# Access Compliance Report

### (Curb Ramps)

Intersection ID: 10019902	Main Street: ARCO_CORPORATE_DR	Cross Street: N/A	Location: NW
ADA ID: C6B663544EDE	Ramp Type: PerpDiag	Initial Pass/Fail: Fail	Overall Compliance: No
Severity Score: 46.25			
Codes/Mitigation Info/Possible Solution		Field Measurements/Component Compliance

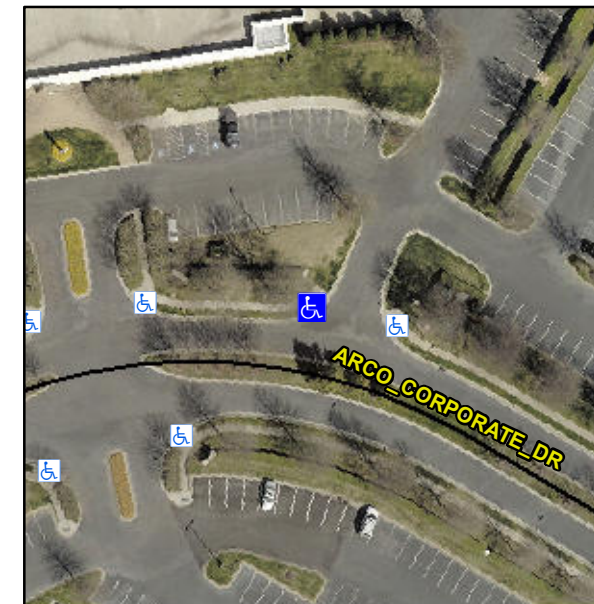
**R304.5.1, R304.2.2, R304.5.3**

Compliance	Description	Data	Compliance	Description	Data
N/A	Ramp Length (in)	46.5	No	Ramp Slope (%)	12.3
No	Ramp Width (in)	37.8	No	Ramp XSlope (%)	5.1
N/A	Flare Type LT	N/A	N/A	Flare Type RT	N/A
N/A	Flare Slope LT (%)	N/A	N/A	Flare Slope RT (%)	N/A
N/A	Flare Traversable LT?	N/A	N/A	Flare Traversable RT?	N/A
N/A	Landing Length (in)	N/A	N/A	DWS Provided?	N/A
N/A	Landing Width (in)	N/A	N/A	DWS Contrast?	N/A
N/A	Landing Slope (%)	N/A	N/A	DWS Length (in)	N/A
N/A	Landing X Slope (%)	N/A	N/A	DWS Full Width?	N/A
N/A	Landing Curb? (Y/N)	N/A	N/A	DWS Offset (in)	N/A
N/A	Shared Landing?	N/A			
N/A	Gutter Ponding?	N/A	N/A	Gutter Slope (%)	N/A
N/A	Gutter Lip Ht (in)	1.0	N/A	Gutter X Slope (%)	N/A
N/A	Painted X Walk1?	No	N/A	Painted X Walk2?	No
	X Walk 1 Direction	To SW		X Walk 2 Direction	To SE
N/A	X Walk 1 Width (in)	N/A	N/A	X Walk 2 Width (in)	N/A
	X Walk 1 Slope (%)	1.1		X Walk 2 Slope (%)	1.5
	X Walk 1 X Slope (%)	2.0		X Walk 2 X Slope (%)	3.0

**Remove & Replace Curb Ramp With Two New Directional Ramps or Equivalent.**
